Docket Number:	19-SPPE-03
Project Title:	Sequoia Data Center
TN #:	232341
Document Title:	Sarvey Response
Description:	Intervenor Sarvey's response to Staff and applicant comments on cumulative i9mpact assessment motion
Filer:	Robert Sarvey
Organization:	Robert Sarvey
Submitter Role:	Intervenor
Submission Date:	3/9/2020 11:54:54 AM
Docketed Date:	3/9/2020

Sequoia Data Center

Docket 19-SPPE-03

Intervenor Sarvey's Response to Staff and Applicant on Cumulative Impact Assessment

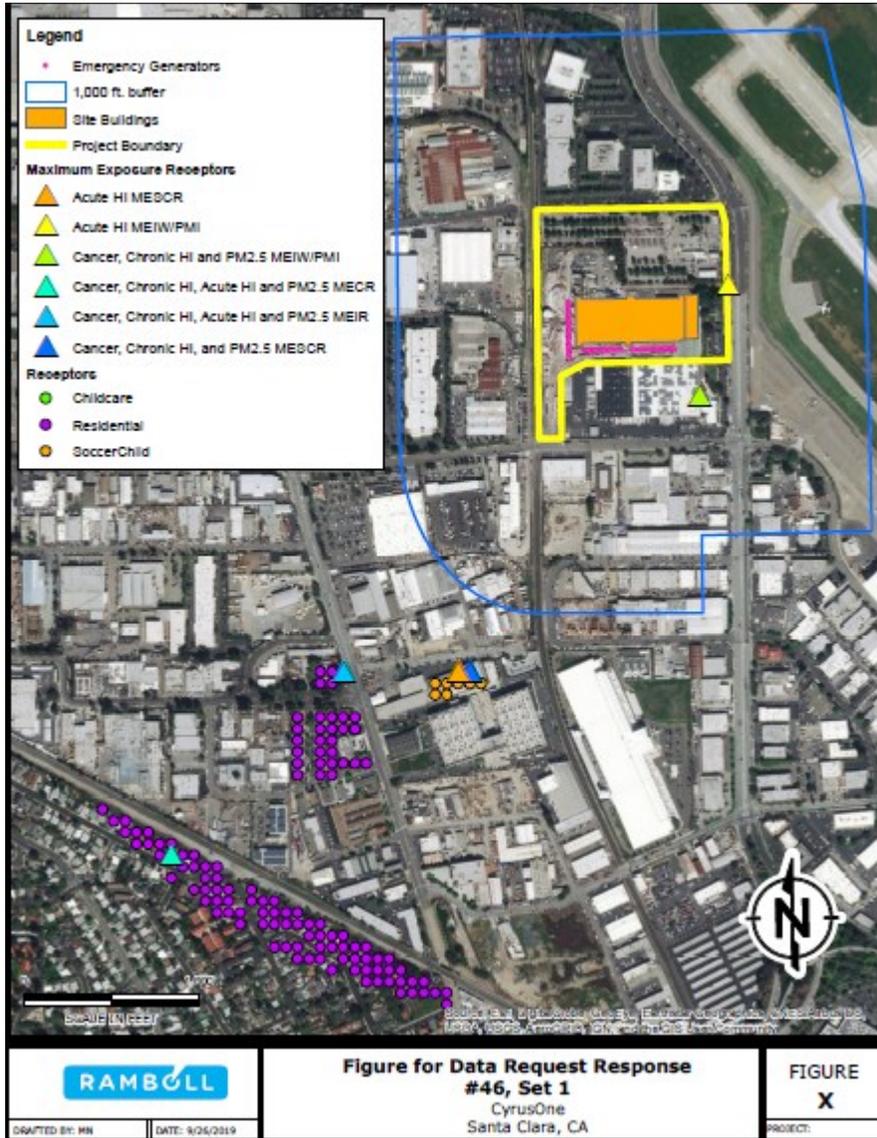
Evidence in the McLaren and Sequoia data center proceedings show the two projects impact the same sensitive receptors and general areas. The Sequoia Data Center's emissions impact a youth soccer field in Santa Clara depicted below in the orange triangle.⁷ The large white building to the right of the soccer field is the Santa Clara Data Center with its 32 diesel generators totaling 72 MW which was approved by the CEC in 2012.⁸ Because of the Santa Clara Data Centers high NO₂ and TAC impacts BAAQMD restricted operations of the project to 700 hours combined for all generators including emergency operation. BAAQMD also limited the times when the generators could be tested, "The owner/operator shall further limit the hours of operation from 12am to 8am

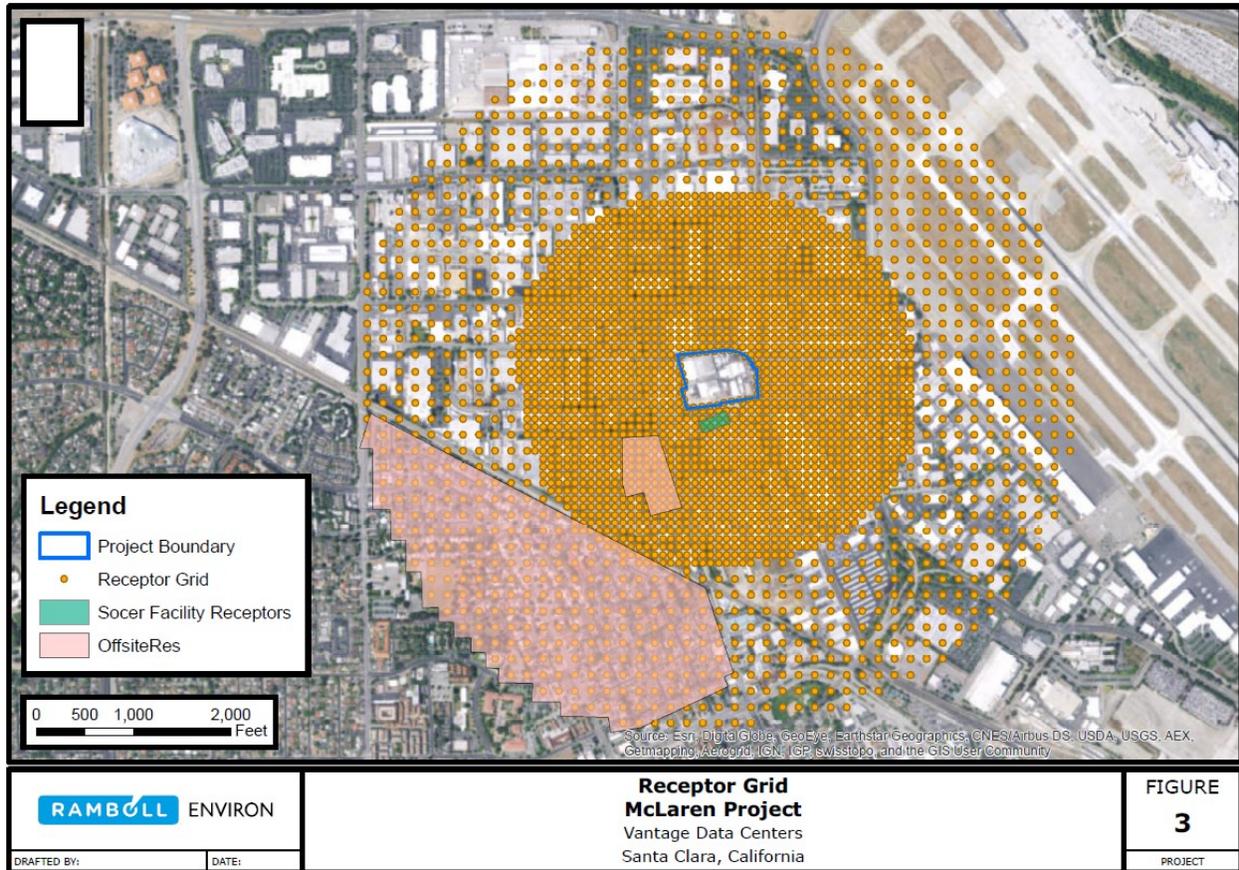
The same youth soccer field is across the street from the McLaren Data Center as depicted in the green rectangle in the map below from the McLaren Data Center proceeding.

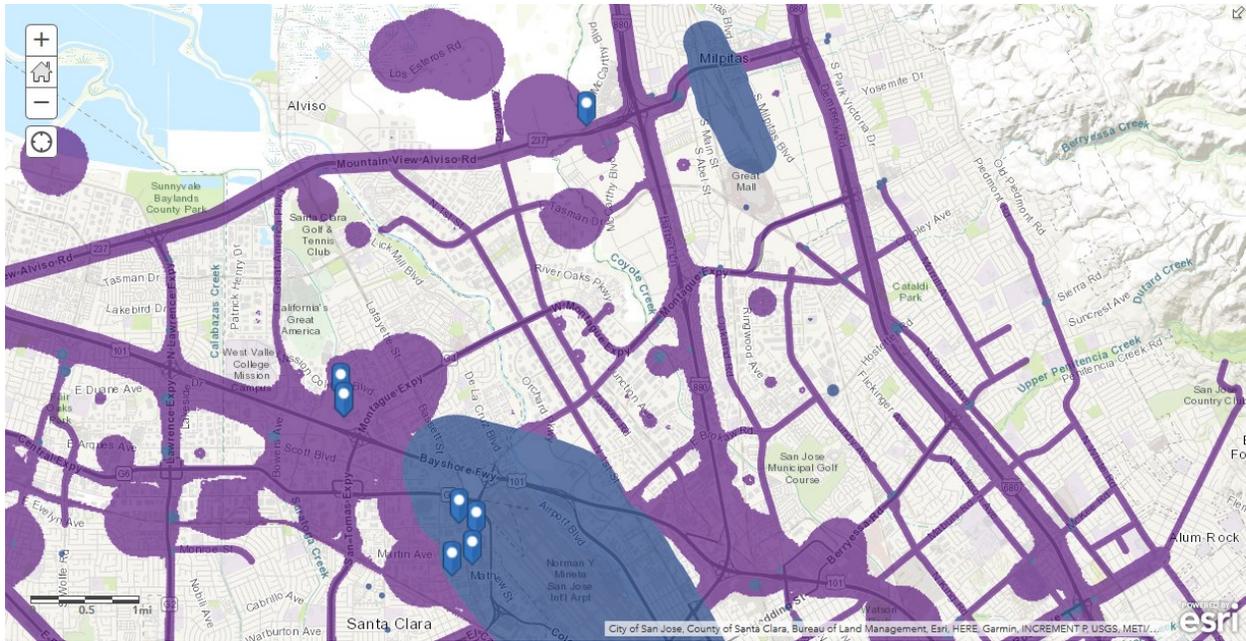
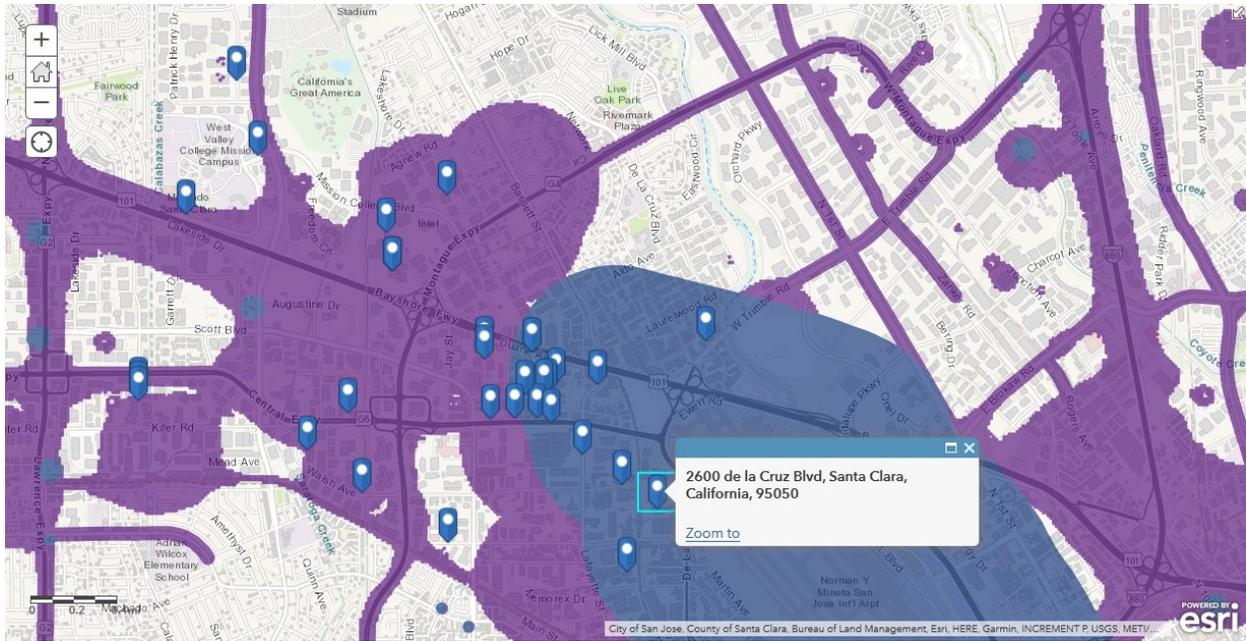
The project area is home to 50 operating data centers currently. The CEC has approved or is reviewing eight different data centers all employing diesel backup generating units.⁴³ The City of Santa Clara has recently approved more than 5 additional data centers in Santa Clara totaling over 120 MW of diesel engines. Every one of these data centers impacts an environmental justice community that according to BAAQMD is already overburdened as depicted in the blue and purple areas of the maps

in Appendix A. CEQA and BAAQMD regulations, and environmental justice considerations require that a cumulative impact analysis be performed to assess the projects cumulative impacts in conjunction with the multitude of data centers that are being permitted by the CEC and the City of Santa Clara.
